Access Compliance Report

Public Rights-of-Way

(Curb Ramps)

Intersection ID: 13787	Main Street: CHARLOTTETOWNE_AV	Cross Street: E_4TH_ST	Location: E
ADA ID: 9553B8433B97	Ramp Type: Perp	Initial Pass/Fail: Fail	Overall Compliance: No
Severity Score: 8.75			
Codes/Mitigation Info/Possible Solution		Field Measurements/Component Compliance

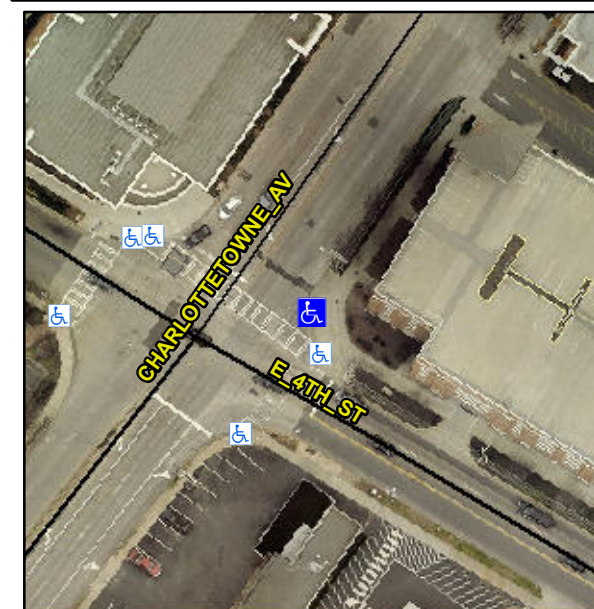
Not Found, R304.5.1

Compliance	Description	Data	Compliance	Description	Data
N/A	Ramp Length (in)	103.0	Yes	Ramp Slope (%)	7.0
No	Ramp Width (in)	47.5	Yes	Ramp XSlope (%)	1.3
N/A	Flare Type LT	N/A	N/A	Flare Type RT	N/A
N/A	Flare Slope LT (%)	N/A	N/A	Flare Slope RT (%)	N/A
N/A	Flare Traversable LT?	N/A	N/A	Flare Traversable RT?	N/A
N/A	Landing Length (in)	N/A	N/A	DWS Provided?	N/A
N/A	Landing Width (in)	N/A	N/A	DWS Contrast?	N/A
N/A	Landing Slope (%)	N/A	N/A	DWS Length (in)	N/A
N/A	Landing X Slope (%)	N/A	N/A	DWS Full Width?	N/A
N/A	Landing Curb? (Y/N)	N/A	N/A	DWS Offset (in)	N/A
N/A	Shared Landing?	N/A			
N/A	Gutter Ponding?	N/A	N/A	Gutter Slope (%)	N/A
N/A	Gutter Lip Ht (in)	N/A	N/A	Gutter X Slope (%)	N/A
N/A	Painted X Walk1?	No	N/A	Painted X Walk2?	N/A
	X Walk 1 Direction	To NW		X Walk 2 Direction	N/A
N/A	X Walk 1 Width (in)	N/A	N/A	X Walk 2 Width (in)	N/A
	X Walk 1 Slope (%)	0.3		X Walk 2 Slope (%)	N/A
	X Walk 1 X Slope (%)	0.2		X Walk 2 X Slope (%)	N/A

Remove & Replace Entire Ramp.
